To: T10 Technical Committee  
From: Rob Elliott, HP ([elliott@hp.com](mailto:elliott@hp.com))  
and Mallikarjun Chadalapaka ([cbm@rose.hp.com](mailto:cbm@rose.hp.com))  
Date: 18 July 2002  
Subject: T10/02-232r2 SAM-3 SPC-3 SBC-2 SSC-2 Clearing effects of I\_T nexus loss

**Figure 1. Power on, hard reset, logical unit, and I T nexus loss relationships**

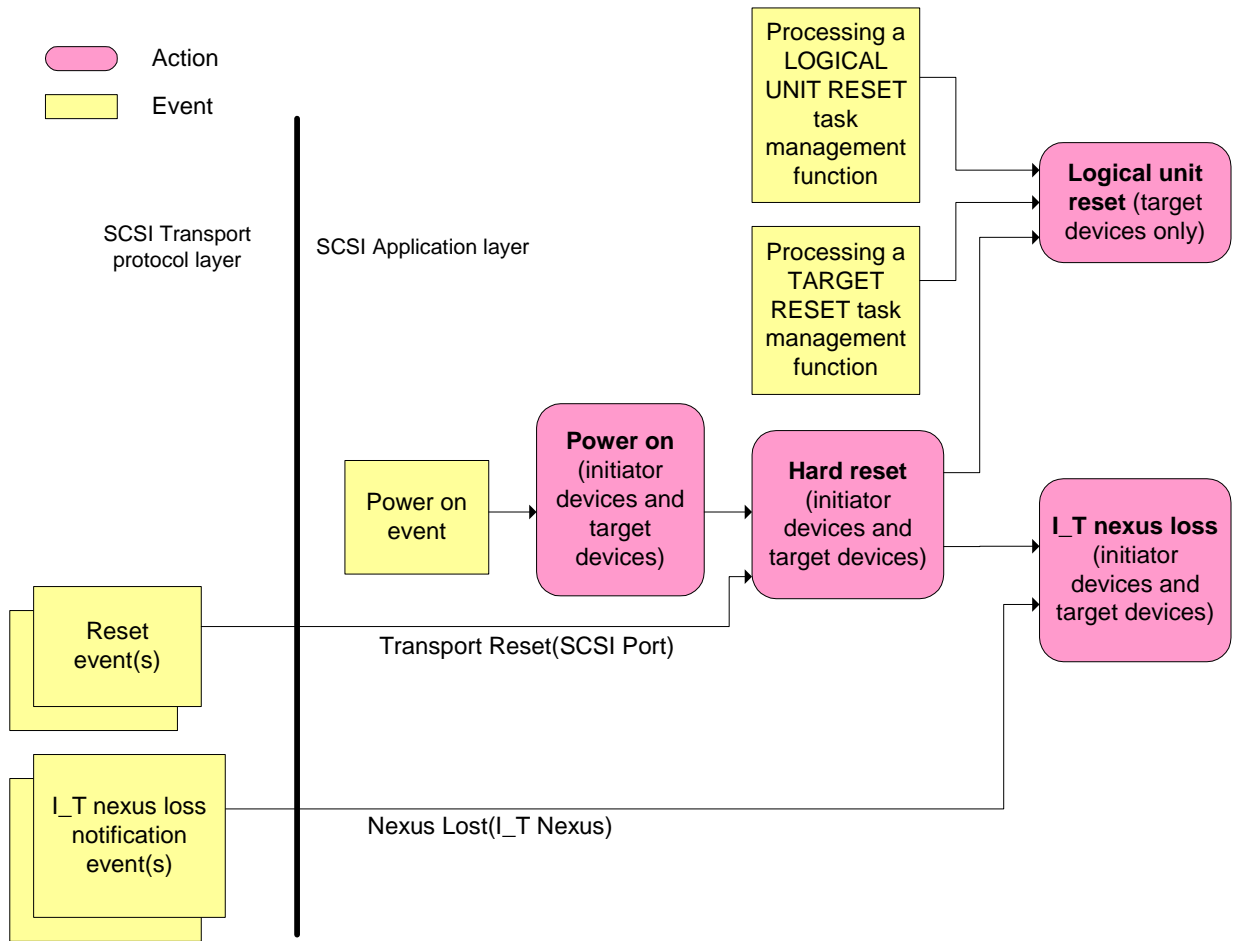
Figure 1 shows the relationships between these actions:

- a) power on (see N.1.2);
- b) hard reset (see N.1.3);
- c) logical unit reset (see N.1.4); and
- d) I\_T nexus loss (see N.1.5),  
and their associated events.
